Draft: ECE-R XXX

Testing: Mechanical coupling devices for agricultural vehicles

**Uniform Provisions Concerning the Approval of Mechanical Coupling Components for
Agricultural Vehicles**

Figure 1— Vertical load in the latching

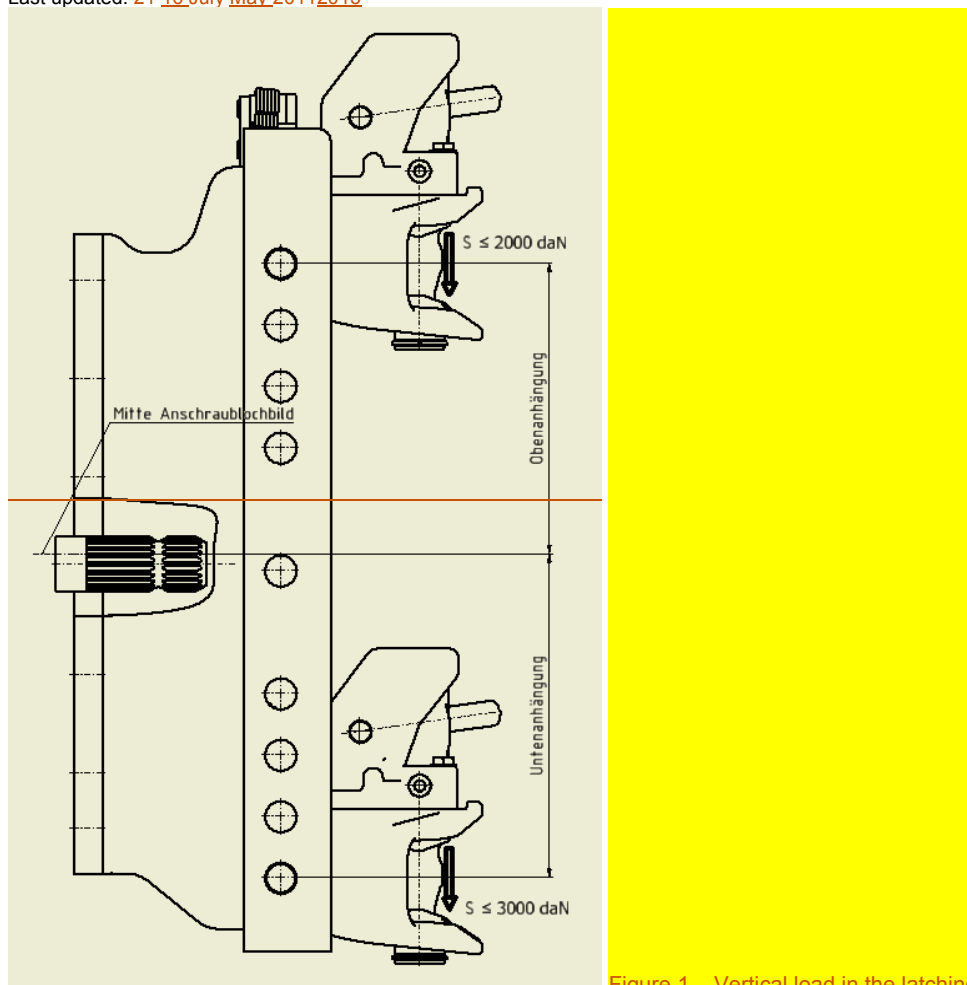
~~4.9 The maximum vertical load for coupling devices on the rear of a tractor may not exceed 4000 daN. Quick height-adjustable towing devices in the latching rail may not exceed 3000 daN. A maximum of 2000 daN is permissible above the centre of the drilling pattern for mounting of the power take-off.~~

~~Vertical loads in excess of 4000 daN are only permissible for coupling devices which are mounted between the axles.~~
